The Cherry Creek Mines project (CCM) is a proposal to cleanup 6 abandoned mines within the Prescott National Forest (PNF) in Yavapai County, Arizona.

This project has developed a Draft Final, Engineering Evaluation/Cost Analysis (EE/CA) document dated November 2017 <a href="https://www.fs.usda.gov/Internet/FSE\_DOCUMENTS/fseprd859781.pdf">https://www.fs.usda.gov/Internet/FSE\_DOCUMENTS/fseprd859781.pdf</a> (export to PDF for bookmarks) The PNF has posted this EE/CA for a public review and comment period that ends on January 30, 2021 This petition is presented in a timely manner.

Marked up 1943 map

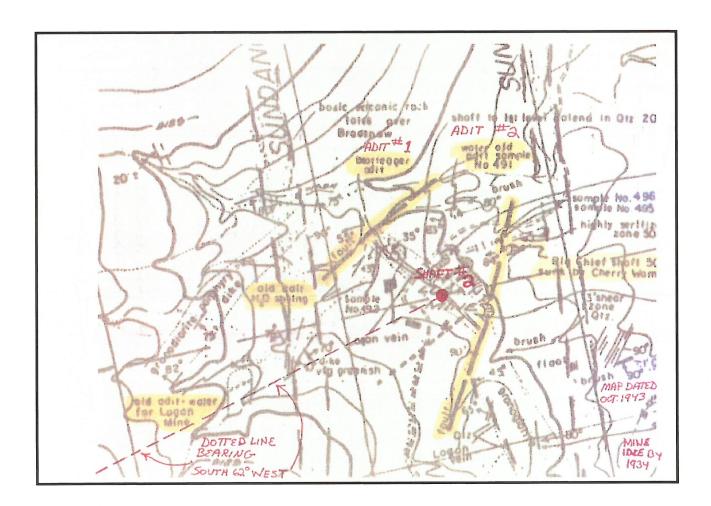
Zoom into the actual Logan Mine area on the 1943 map. Presented below is my marked up copy of the actual mine site showing multiple water features that prove the Logan Mine is flooded.

The red dot is the 600 foot shaft known as shaft #2. On your own downloaded map, look to the right of this shaft to see its description. The shaft inclines south 62 degrees west to a depth of 600 feet. I have plotted this bearing and it places the shaft directly under a feature labeled *'old adit-water for Logan Mine'* meaning, water for the mill. I have discovered that a significant amount of water is flowing out of this feature and several large, abandoned livestock watering troughs are in place. Abandoned sources of water in Arizona are a good indication that the water is already contaminated.

On the 1943 map, just northeast of the 1st old adit is 'old adit H2O spring' I have also confirmed the locations of adit #1 & #2. Note that this old map labels adit #2 as, 'water old adit' To this day, water is flowing from the lower section of adit #2. The EE/CA photo #191 dated 4/4/2017 shows a pool of water in the lower right side. Photo # 192 showed a stream of water flowing from that pool. Note the descriptions and compare it to photos #172 & 173 of the Uncle Sam Mine. The USFS will not describe or acknowledge the water at the Logan Mine, even though it is undoubtedly flooded.

Sadly, there are two dark lines near the 600 foot shaft collar, labeled, **Fault**. Deep cracks in the earth that can act as conduits to allow contaminated water into Yavapai Counties Ground Water System. This is the last thing the USFS wanted anyone to see.

Portion of 1943 letter

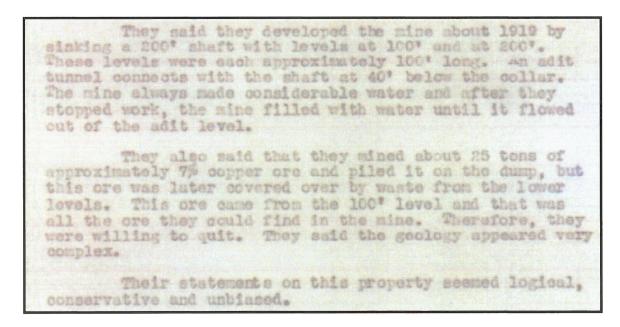
The EE/CA states that the Uncle Sam mine shaft #1 is only '40 feet deep with water at the bottom'. From the letter we now know that it is 200 feet deep and flooded.

Just like the 50 foot depth at the Logan Mine, the USFS uses a 40 foot number that is only contained in a document they claim to have never discovered. This shaft is fenced off and inaccessible. As they stated, 'they estimated all mine shaft depths'.
